MEMORANDUM

TO: District of Columbia Zoning Commission

SUBJECT: **Setdown Report** for ZC #11-03J, Wharf Parcels 6 through 10
First Stage PUD Modification and Second Stage PUD Application

Approved 1st Stage PUD – Pier and Dock Layout

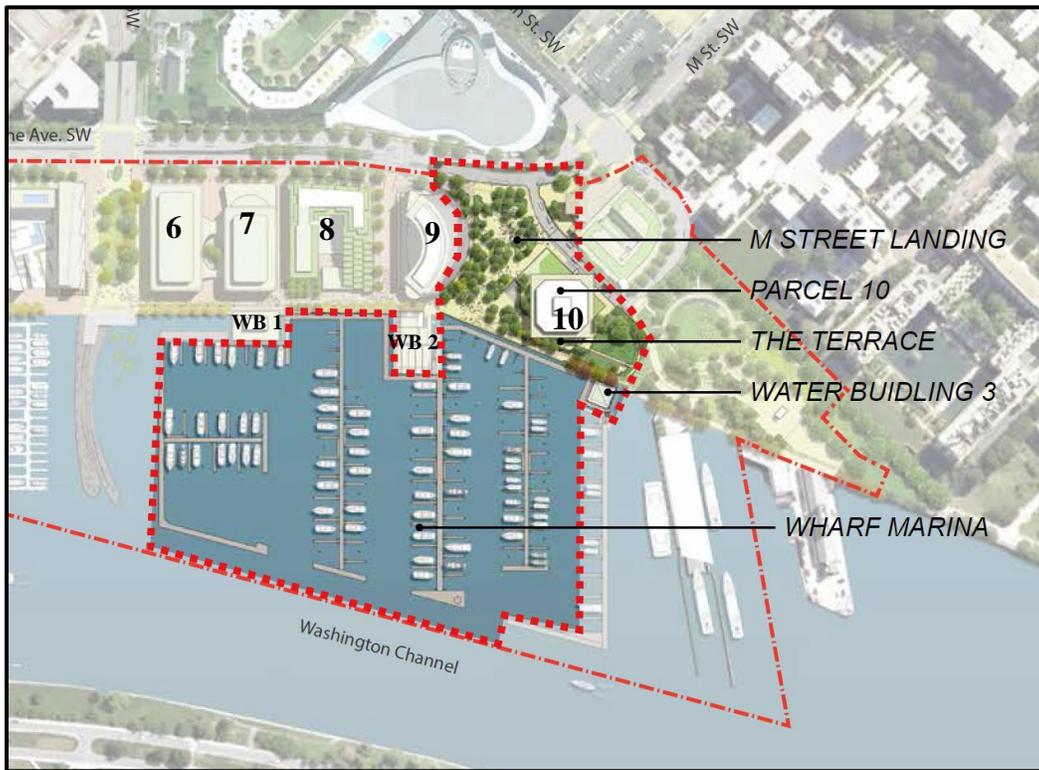
Although not requested, OP believes a first stage PUD modification is also required for the layout of the piers, docks and water buildings that are included in this application. The approved first stage PUD showed a large “Commercial Pier” in the location of the current Pier 3 (the Cantina Marina Pier), which would be a rehabilitation of the existing pier or an in-kind replacement, along with an expansion. Please refer to Sheet 2.8 of Exhibit 26A in case 11-03, as well as the image below. The Commercial Pier would have had a 2-story retail pavilion. As currently proposed, the water side would have no commercial pier, but would instead have docks comprising the Wharf Marina. The cruise boat operations formerly slated for the Commercial Pier have been moved to Pier 4, and many of the retail functions seem to have moved to Water Building 2, which has increased considerably in size.
